**ITEM TITLE:** Resolution PC 24 03 DR 01 (*formerly CUP 03*), Siuslaw Estuary Trail

**RESOLUTION PC 24 03 DR 01** *(Previously CUP 03)*

**FINDINGS OF FACT  
FLORENCE PLANNING COMMISSION  
Exhibit "A"**

**Public Hearing Date:** February 27 & March 12, 2024      **Planner:** Clare Kurth &  
**Application:** PC 24 03 DR 01 (Previously CUP 03)      Wendy FarleyCampbell

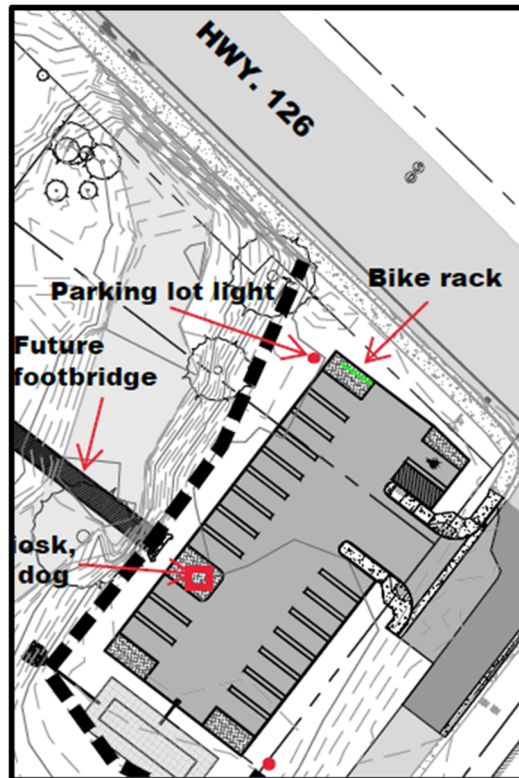
Two parking lot lights are proposed with this parking lot. One is in the northwest corner adjacent to the proposed bike parking location and the other is located near the southeast corner of the parking lot. The northwestern light location is anticipated to provide adequate lighting for security and will be at least as well-lit as other vehicle parking stalls. This criterion is met.

NRCS Soils Map, 2009 Excerpt

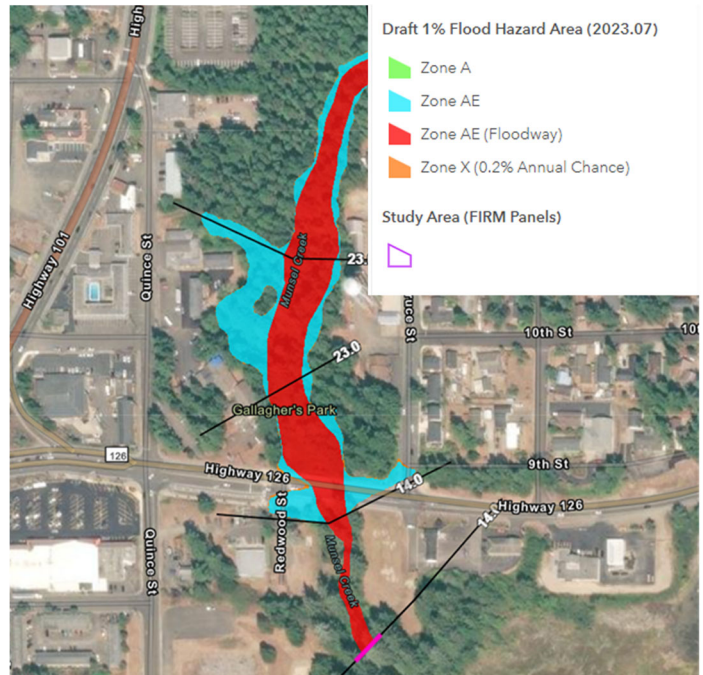
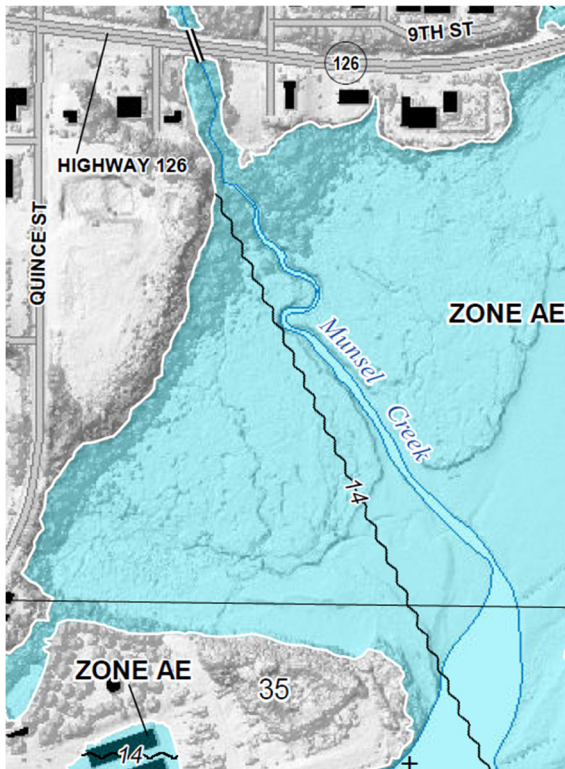
The project is located in the following problem areas listed above: Soils Map (Waldport fine sand 12 to 30 % slopes & Brallier variant muck), Hazards Map (100-year Floodplain & Near and Distant Tsunami Inundation Areas). See next page for excerpts.

No structures are proposed in the special flood hazard zone or in the tsunami inundation areas. On the Waldport soils the proposal includes a cut and fill plan for grading designed by a registered engineer. Sheets C8 and C1 address drainage. The sheets include plans for revegetation of cut and fill areas outside of the trail location. No structures are proposed in the Brallier soils and so

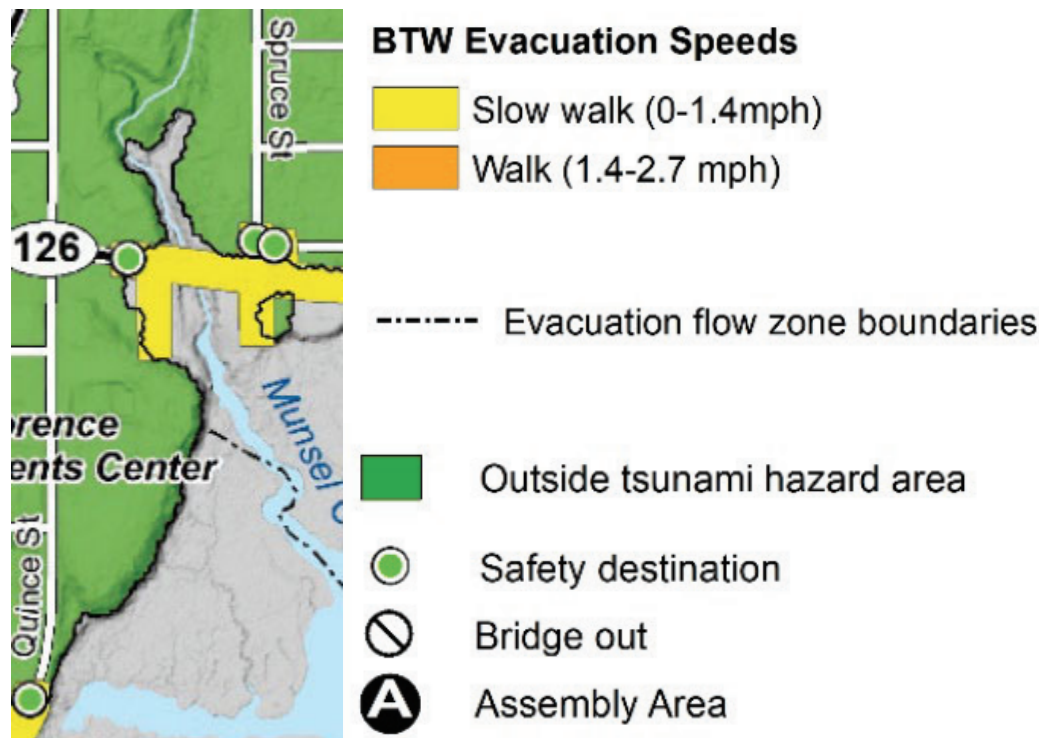
The evacuation route analyses and Beat the Wave modeling performed in 2018 identified Quince St. near the trail head, Hwy 126 at Redwood St. and 9<sup>th</sup> St. on Spruce St. as a safety destination areas. See below from Figure 3-14. The signage plan for the project shall include evacuation information to direct pedestrians to the safety destination areas. **(Condition 8)**
